Access Compliance Report Public Rights-of-Way (Curb Ramps)

Intersection ID: 10675 Main Street: HERRIN_AV Cross Street: THE_PLAZA Location: E

ADA ID: 89C8D01DDD1A Ramp Type: Perp Initial Pass/Fail: Fail Overall Compliance: No Severity Score: 25

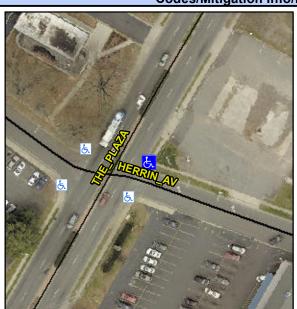
Not Found, R304.5.3

Fleid Measurements/Component Compnance					
Compliance Description		Data	Compliance Description		Data
N/A	Ramp Length (in)	83.5	Yes	Ramp Slope (%)	5.0
Yes	Ramp Width (in)	87.0	No	Ramp XSlope (%)	9.2
N/A	Flare Type LT	N/A	N/A	Flare Type RT	N/A
N/A	Flare Slope LT (%)	N/A	N/A	Flare Slope RT (%)	N/A
N/A	Flare Traversable LT?	N/A	N/A	Flare Traversable RT?	N/A
N/A	Landing Length (in)	N/A	N/A	DWS Provided?	N/A
N/A	Landing Width (in)	N/A	N/A	DWS Contrast?	N/A
N/A	Landing Slope (%)	N/A	N/A	DWS Length (in)	N/A
N/A	Landing X Slope (%)	N/A	N/A	DWS Full Width?	N/A
N/A	Landing Curb? (Y/N)	N/A	N/A	DWS Offset (in)	N/A
N/A	Shared Landing?	N/A			
N/A	Gutter Ponding?	N/A	N/A	Gutter Slope (%)	N/A
N/A	Gutter Lip Ht (in)	N/A	N/A	Gutter X Slope (%)	N/A
N/A	Painted X Walk1?	No	N/A	Painted X Walk2?	N/A
	X Walk 1 Direction	To SW		X Walk 2 Direction	N/A
N/A	X Walk 1 Width (in)	N/A	N/A	X Walk 2 Width (in)	N/A
	X Walk 1 Slope (%)	1.1		X Walk 2 Slope (%)	N/A

Remove & Replace Entire Ramp.
